# SERVICE BULLETIN

M-1206

## 2007 SPORTSTER ELECTRICAL DIAGNOSTIC MANUAL UPDATE

The purpose of this service bulletin is to inform you of updates and corrections to the 2007 Sportster Electrical Diagnostic Manual (Part No. 99495-07).

**Figure 4-40.ET Sensor Circuit**

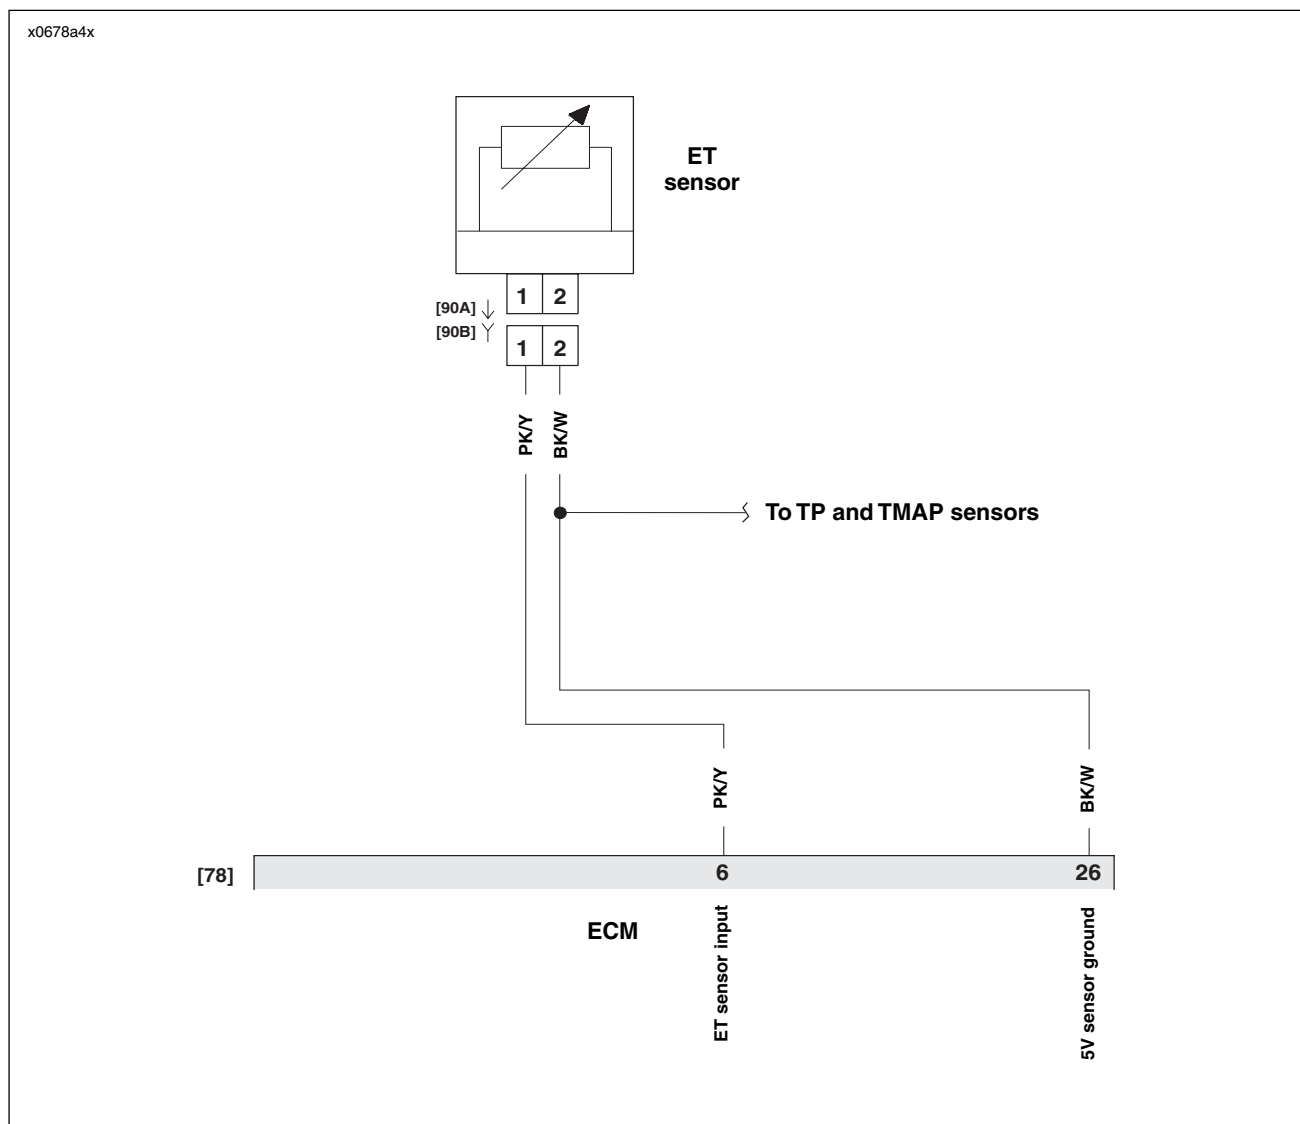
- Replace Figure 4-40 with the figure below.
- Delete the last row ([145] Engine Harness) from Table 4-23.

**Figure 1. Engine Temperature (ET) Sensor Circuit:  
Old (top) and New (bottom)**

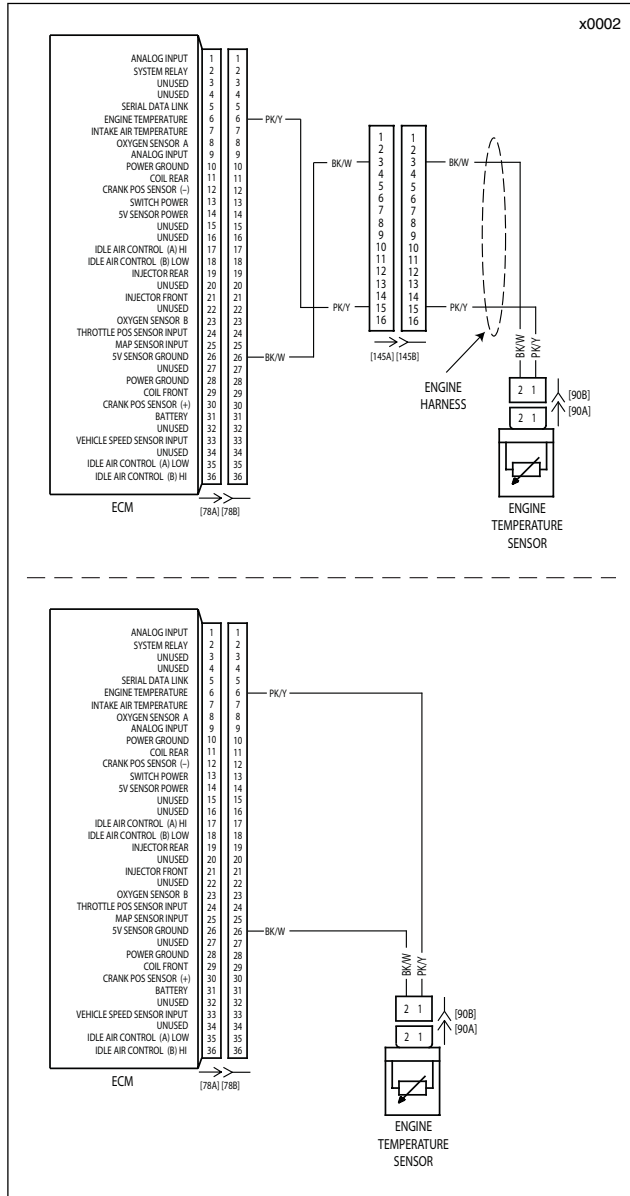
- Change the Engine Management schematic on page 5-41 to reflect the change shown in Figure 1 below.

**Figure 2. XL 1200N Rear Lighting (add to page 5-47,  
2007 Sportster Electrical Diagnostic Manual)**

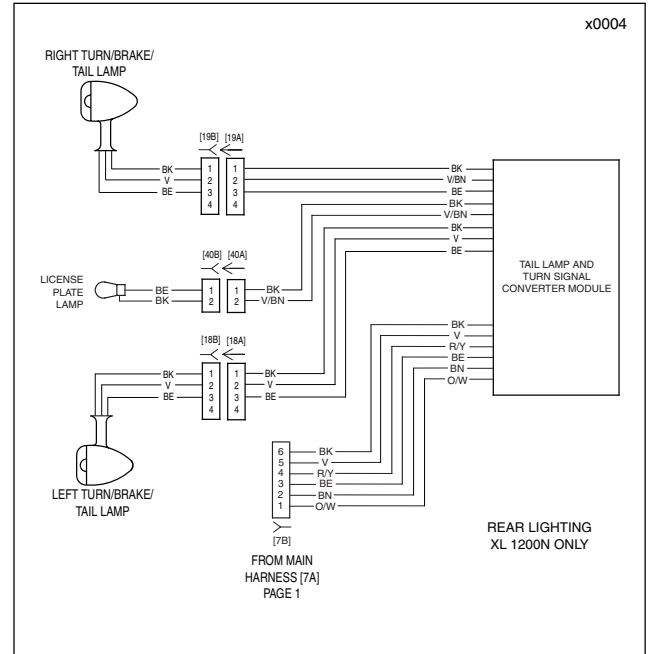
- Change the description of the schematic in the bottom right corner of page 5-47 from "REAR LIGHTING" to "REAR LIGHTING, ALL EXCEPT XL 1200N".
- Add the schematic in Figure 2 below to the schematics on page 5-47.
- Change the description of the schematic in the bottom right corner of page 5-53 from "REAR TURN SIGNALS" to "REAR TURN SIGNALS, ALL EXCEPT XL 1200N".
- Add the schematic in Figure 3 below to the schematics on page 5-53.

Figure 2-17.Fuel Sender Circuit

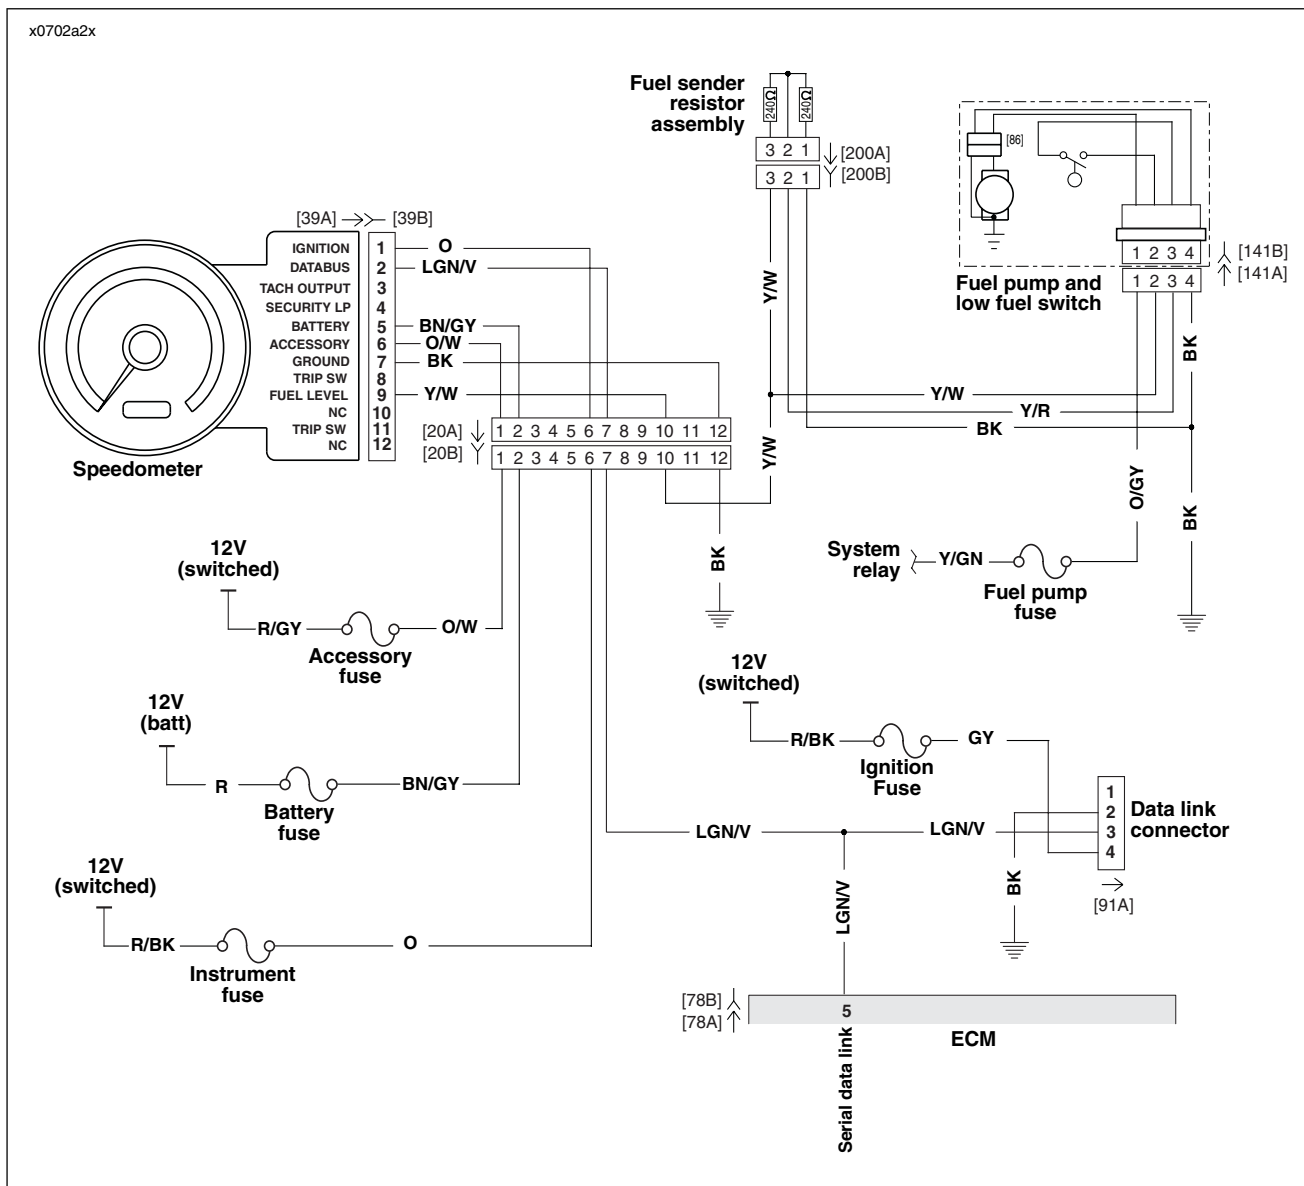
17. Replace Figure 2-17 on page 2-22 with Figure 2-17 below.

## Turn Signal Error 2A

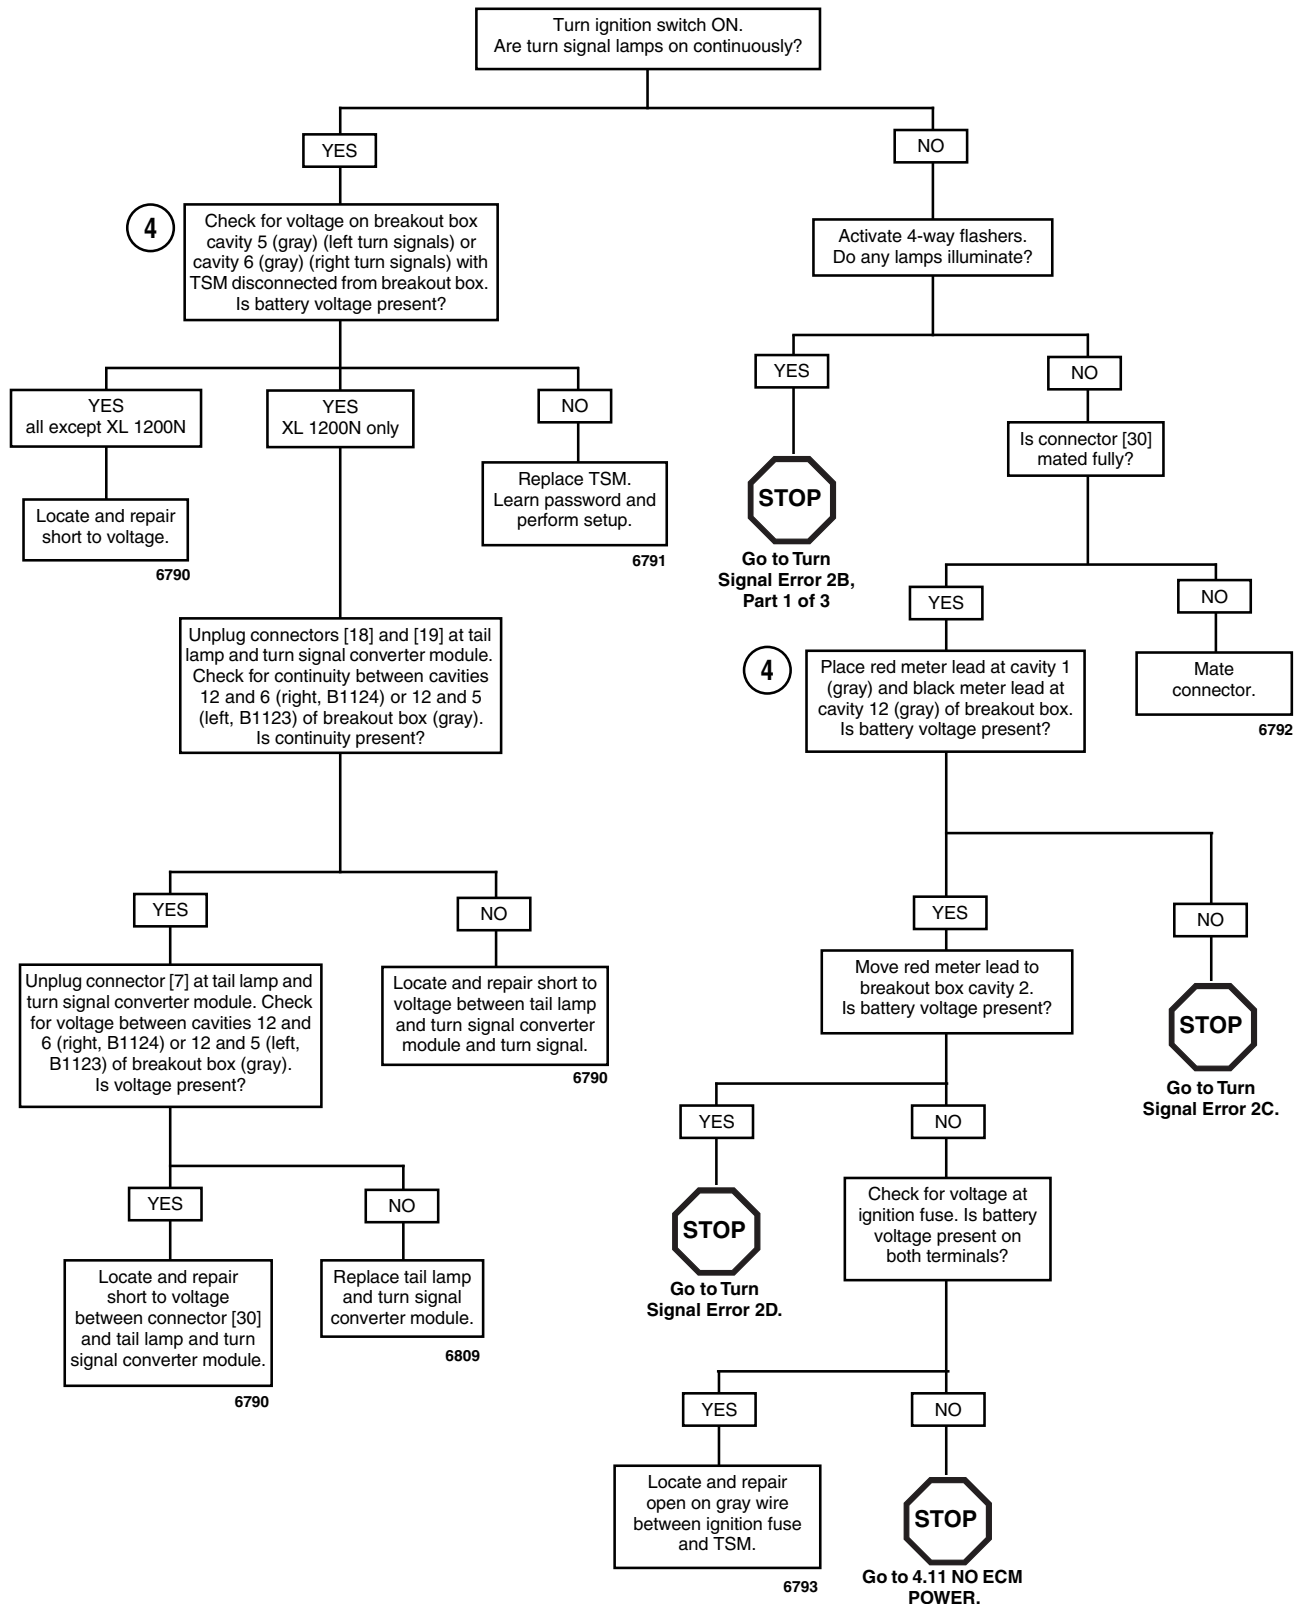
1. See Table 1-1, page 1-1. Change third item in left column from "Handlebar start switch" to "Handlebar start switch, clutch switch or neutral switch".
2. See Table 1-4, page 1-20. Add a row in the table and insert the following: under "ITEM", insert "ECM". Under "DRAW IN MILLIAMPS", insert "1.0".
3. See 3.7 SERVICE/EMERGENCY FUNCTIONS on page 3-14. Step 3 under TRANSPORT MODE should read as follows: "With an assigned fob within range, turn the ignition/headlamp key switch from IGNITION to ACCESS."
4. Rename "Turn Signal Error 2A" on page 3-41 to read, "Turn Signal Error 3A".
5. Replace page 3-42 (Turn Signal Error 3A (Part 1 of 4)) with "Turn Signal Error 2A" and its flow chart on page 5 of this document.
6. Replace page 3-43 (Turn Signal Error 3A (Part 2 of 4)) with "Turn Signal Error 2B (Part 1 of 3) through (Part 3 of 3)" and their flow charts on pages 6 through 8 of this document.
